STRUCTURAL ADDENDUM S01

To: G.M. Diemert Architect Inc.
Contract: Lion's Head Rotary Building Renovations and Addition
Contract Number: 2920
Date of Issue: 2017-10-04
Add. No.: S01
Permit Number: n/a

This addendum modifies the original drawings and specifications issued for tender as per the following:

The purpose of this request is to provide clarity due to discrepancies on the drawings and specifications.

Part Foundation Plan

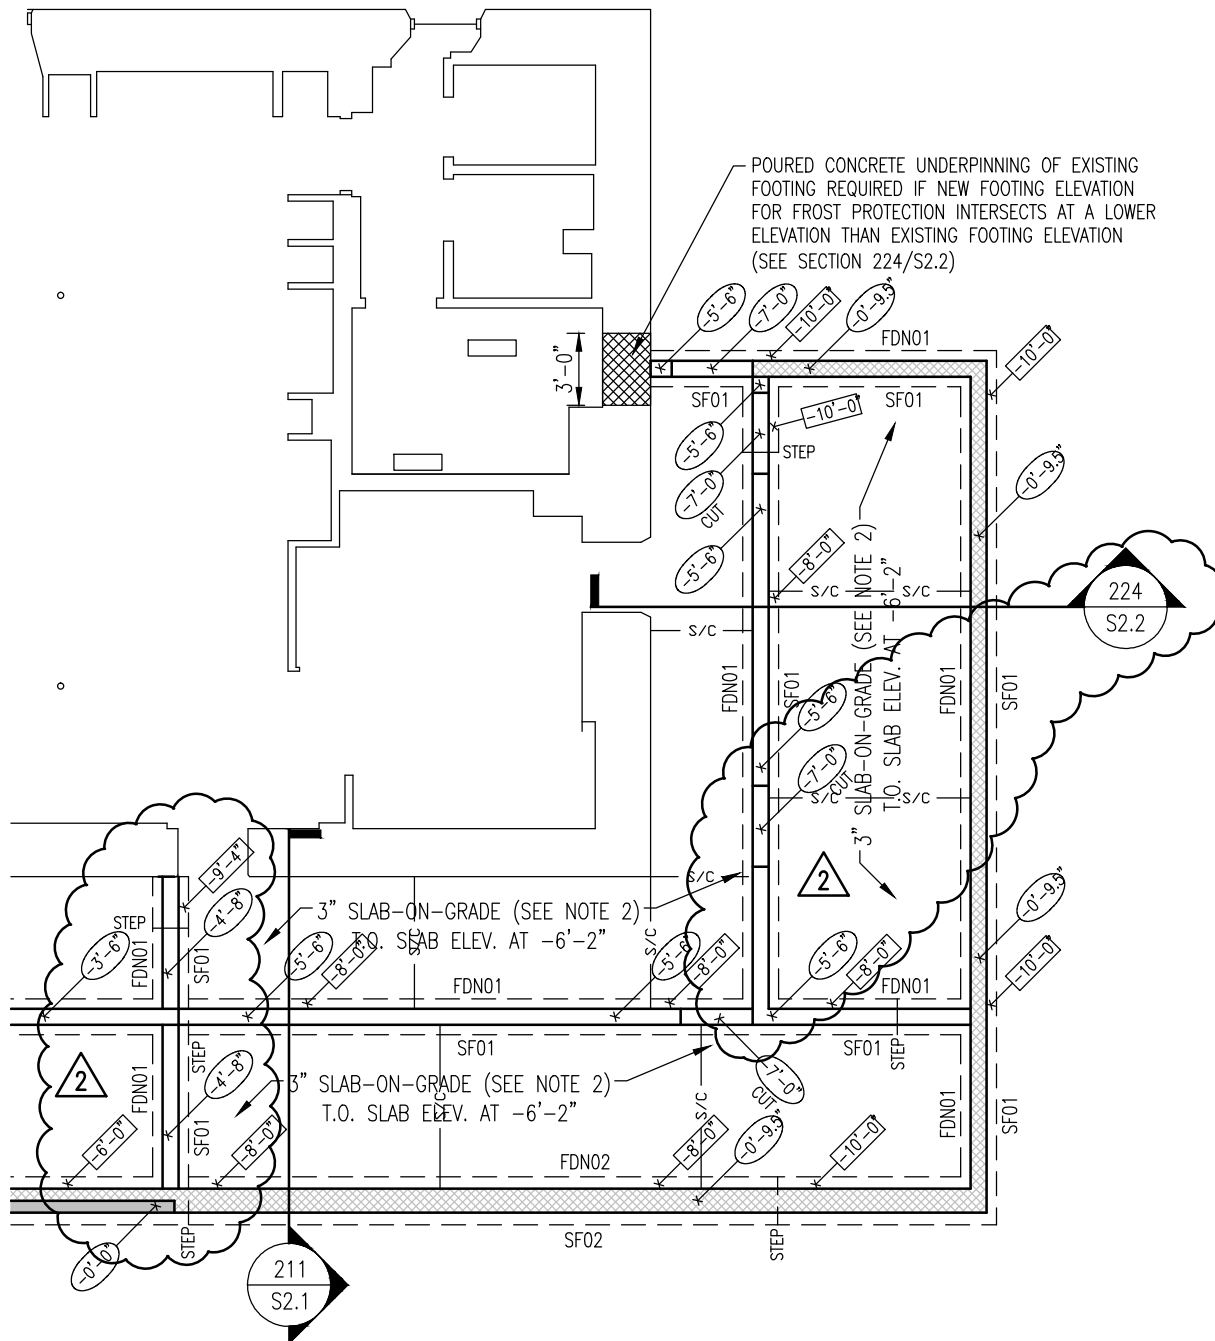
1. Section marker noted as 224/S2.2 on the west foundation wall shall be adjusted to read 221/S2.2.
2. Thickened foundation wall FDN03 shall be provided with 3" high x 8" wide upstand and sloped surface for architectural bench. See sketch SK200.

3. Foundation wall between entry and crawl space to be provided with 6" wide upstand with lower ledge at -1'-4 1/2" +/- . See sketch SK200.
4. Foundation cut for entry door should be noted as +/- to accommodate adjusting of entry slab during construction.

5. Delete new south pad footing at base of existing stairwell. See sketch SK200
6. Section marker 111/S1.1 on the West foundation wall shall be noted as 'similar'.

Part Foundation Plan

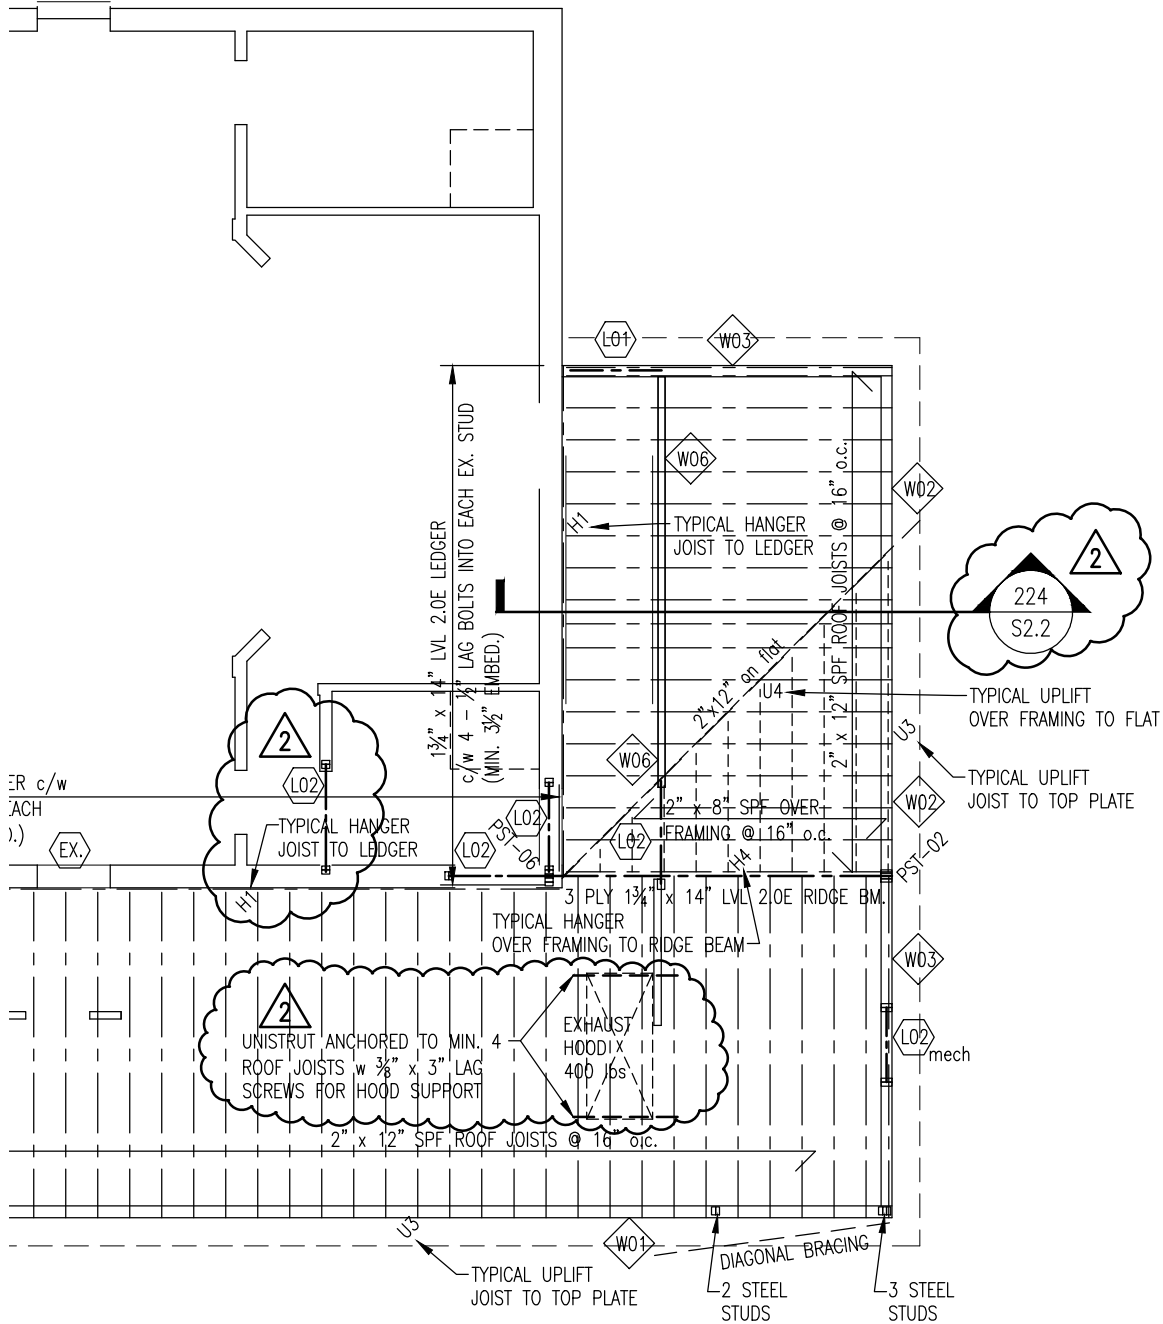
7. Foundation wall elevation between high and low crawl spaces to be adjusted to -4'-8". See sketch SK201.
8. Foundation cut in for crawl space access to be shifted northerly to reflect architectural layout. See sketch SK201.
